AVIA PROPELLER Ltd.

INFORMATION BULLETIN

No.: V 503/2

Refers to: Removal of the leakage of airscrew V 503.

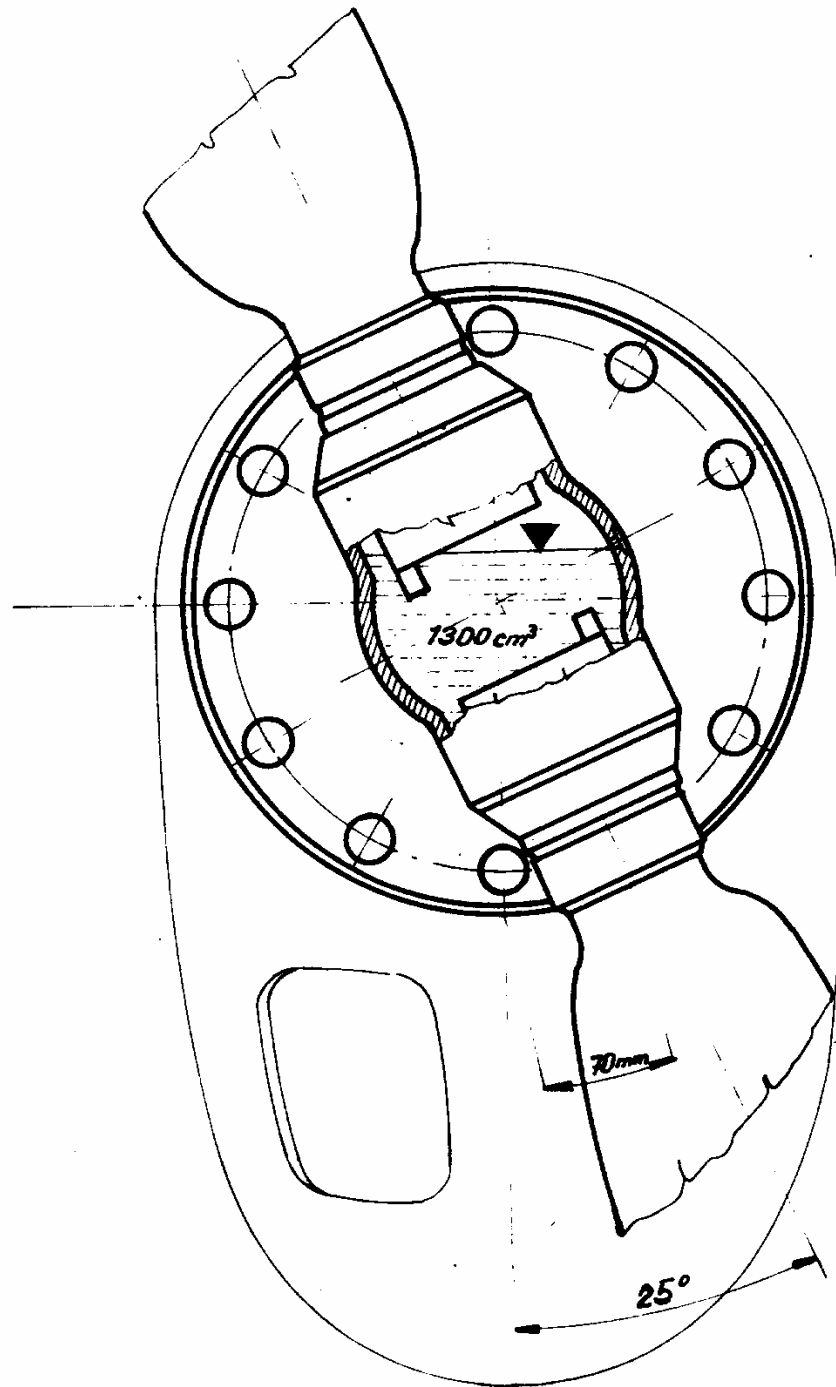
Reason: Recently, in the aircraft traffic, single cases of leakage of control shaft of the servosystem occurred.

Measures: Removal of the leakage of servosystem will be done as follows:

1. Replace the silon packing ring V 503-3003 (pos. 53, Fig. No. 1 in the Technical description of the airscrew V 503) with a new ring, which the user will receive on request by return from the manufacturing plant.

2. Check the quantity of the oil filling in the airscrew hub. In order to carry out this check correctly, it is necessary to set the airscrew in such position, in which the blade axis will include the angle of 25° in relation to the vertical axis of the engine. This position can be set easily with the help of the arch distance between these two axis, which is 70 mm on the circumference of the rear part of the air screw housing (see the Figure on the following page). For detailed description of the check see the Technical description and service instructions of the airscrew V 503; please correct the stated position of about 45° to 25°.

3. In the case, that the leakage will not be removed even after these modifications, it is admissible to reduce the quantity of oil filling in the airscrew by 100 up to 200 ccm.
